DART SERVICE BULLETIN SB18-4

REF. TCCA STC: SH14-14
REF. FAA STC: SR03538NY
REF. ANAC STC: 2014S07-11
REF. JCAB STC: STC-372-OSA/STC-371-OSA
REF. EASA STC: 10056574

It has come to Dart's attention that a QD3072-46 Receptacle on the QB21308 Assembly Screen manufactured by Pall Aerospace as part of the D350-822-011/-013 PA100 PUREair System may have come loose in service, may have been ingested during aircraft ground runs and may have caused FOD damage to the engine on that aircraft.

Figure 1 - QB21308 Assembly Screen

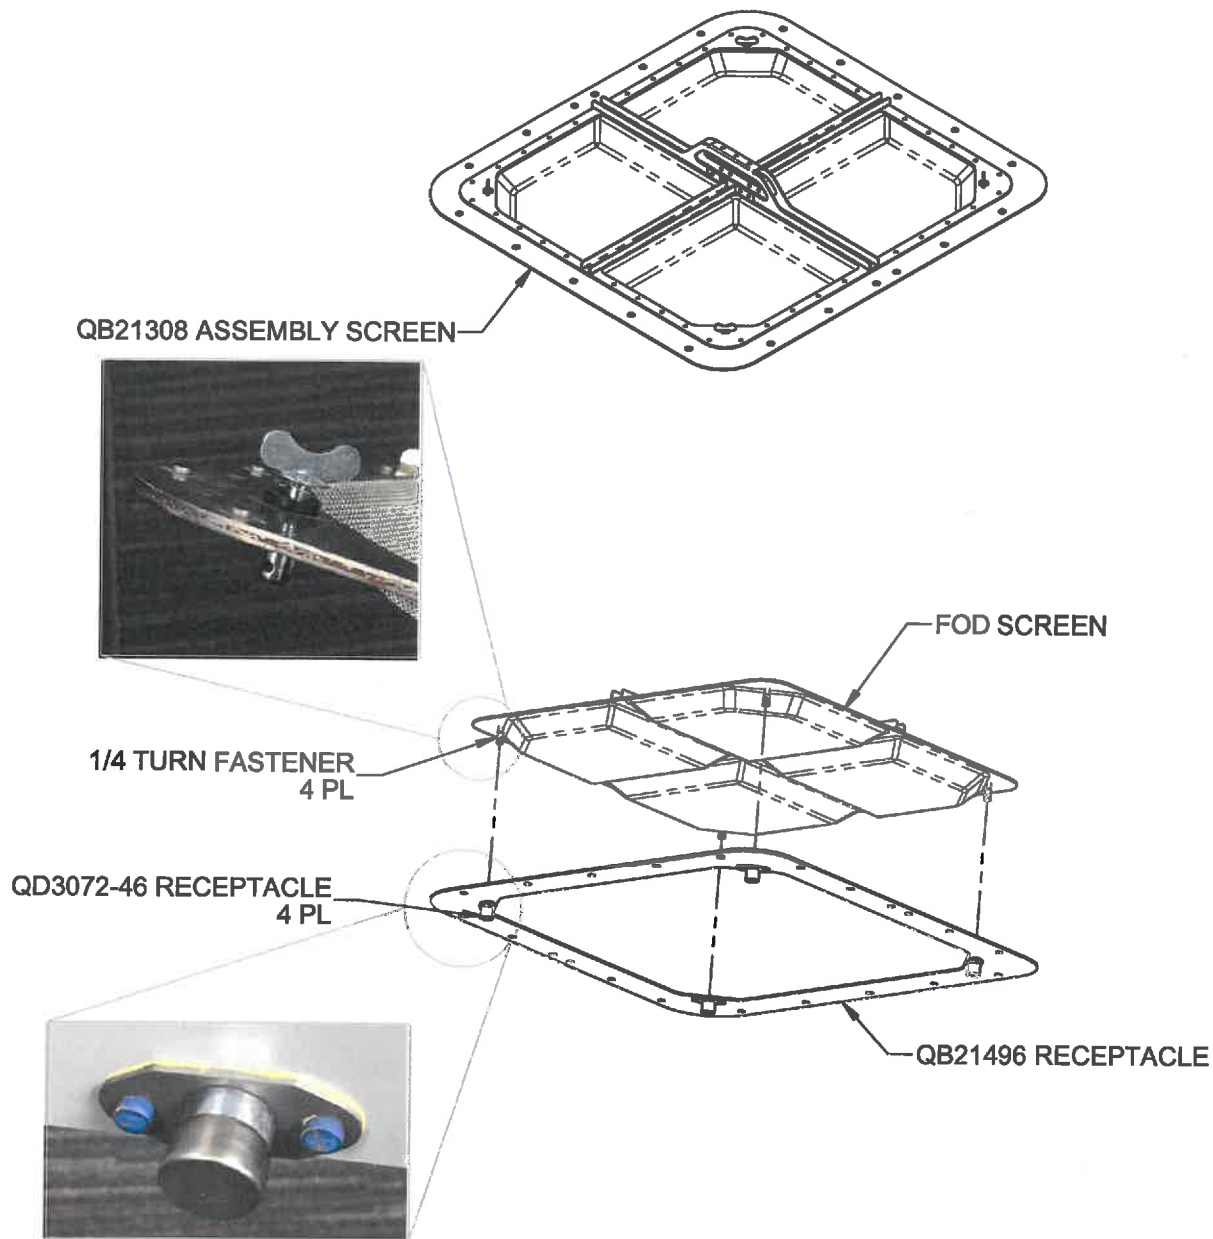
4. Separate the FOD screen from the QB21496 Receptacle by turning the 1/4 turn fasteners and lifting the handle per Figure 1.
5. Inspect the QD3072-46 Receptacles on the backside of the QB21496 Receptacle by applying 10-20 lb (5-10 kg) of finger pressure to ensure that they are not coming loose. A gap between the receptacle barrel and rivet plate is an indication of a loose/damaged receptacle.

6. If any of the QD3072-46 Receptacles are determined to be loose or spinning, contact Dart Customer Support immediately for disposition.
7. If the QD3072-46 Receptacles are determined to be well installed, re-install the FOD screen onto the QB21496 Receptacle. Verify that the 1/4 turn fasteners are fully engaged into the corresponding QD3072-46 Receptacles.

8. Customers who are concerned about the integrity of the QD3072-46 Receptacles may choose to replace them with bolts and non-floating anchor nuts using the DSI 9815-011 kit, which may be procured from Dart.
